Building Code of Australia

Design Compliance Report

195-197 Sydney Road, Fairlight NSW

Report Number & Revision:	MSA1822_REV02
Prepared For:	Micronest Pty Ltd
Date of Issue:	05.10.2018

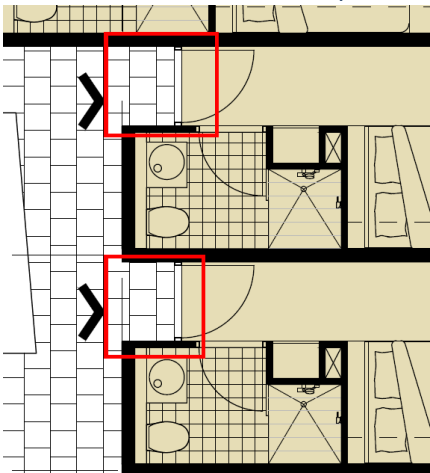
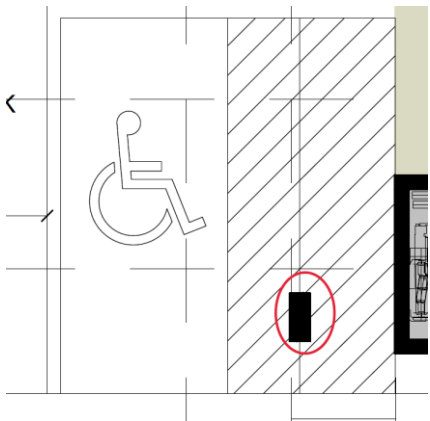
#	DTS Clause	Description of Issue.
1.	C1.1	<p><i>Separation of Skylights</i></p> <p>The skylights in difference units must be not less than 3m apart. See below for <i>example</i> of non-compliant area.</p> <p><i>This will need to be addressed via Performance Solution.</i></p> 
2.	D1.4	<p><i>Exit Travel Distances</i></p> <p>The following travel distance issues should be addressed by design change or by way of Performance Solution:</p> <ul style="list-style-type: none"> Level 02, 03 & 04 – Northern part - the distance between some SOU doorways and the nearest exit exceeds 6m (up to approx. 17m) Level 04 & 05 – Southern part - the distance between some SOU doorways and the nearest exit exceeds 6m (up to approx. 16m) <p><i>This will need to be addressed via Performance Solution.</i></p>
3.	D1.10 D2.12	<p><i>Discharge of Exits + Roof as Open Space</i></p>

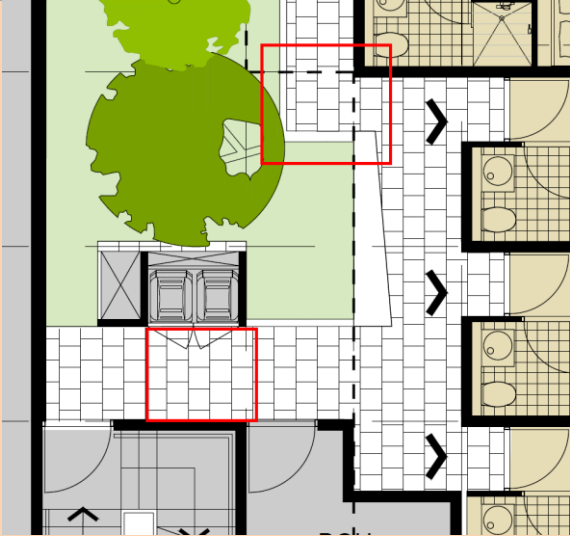
BCA DEEMED-TO-SATISFY PROVISION	SUMMARY OF REQUIREMENT	COMPLIANCE COMMENT/STATUS/RECOMMENDATION
	<ul style="list-style-type: none"> A screen with secure fittings (<i>refer to Clause D2.24 for requirements</i>) <p>Note balustrading may also be required to windows.</p>	
D2.25 Timber Stairways: Concession	Provides a concession allowing timber stairways to be used in fire exits subject to protective measures being provided.	Informational Clause
Part D3 Access for People with Disabilities		
D3.1 General Building Access Requirements	<p>BCA Table D3.1 provides the requirements for access to buildings – primary based on Classification. Areas required to be accessible are typically required to comply with AS1428.1. Requirements are summarised as follows:</p> <ul style="list-style-type: none"> Class 2, 3 & 9c buildings – <i>Common areas</i> - Access must be provided from a pedestrian entrance required to be accessible to at least one floor containing sole occupancy units and to the entrance doors of each sole occupancy unit on that level and where levels are served by a passenger lift, to all unit entrances and common areas of the levels served by a lift. Access must also be provided to one of each type of common room/space for use by residents (kitchens, gyms, pools, laundries, lounge rooms and the like) Class 3 & 9c – SOUS (Accessible SOUs must be provided in accordance with Table BCA D3.1 – the number is calculated on the total number of SOU's provided. Accessible SOU's must be representative of the rooms available and not more than 2 accessible SOUs can be provided adjacent one another. Class 5, 6, 7b, 8, 9a & 9b buildings – Access must be provided to and within all areas normally used by the occupants (additional requirements apply to Class 9b buildings which are not schools). 	<p>Class 3 part – Units</p> <p>At least 4 units should be 'accessible' as per BCA Table D3.1 (based on total number of units being 75). 4 units are proposed as required however detailed fitout plans will be required at CC stage.</p> <p>Class 7a part</p> <p>Access must be provided to and within any level containing accessible carparking (general compliance is achieved)</p> <p>All stairs in common areas (that are not within fire isolated exits) are required to be provided with AS1428.1 compliant handrails to each side. Note that location of stairs may require minor reconfiguration to ensure that compliant handrail extensions can be provided – which do not encroach into accessways or circulation spaces.</p> <p>The accessways in the common areas must provide for a 1.5m x 1.5m turning area where a 90 degree change in direction is required. Furthermore, additional circulation space may need to be provided to allow access to bin areas. See below for <i>example</i> of non-compliant areas:</p>
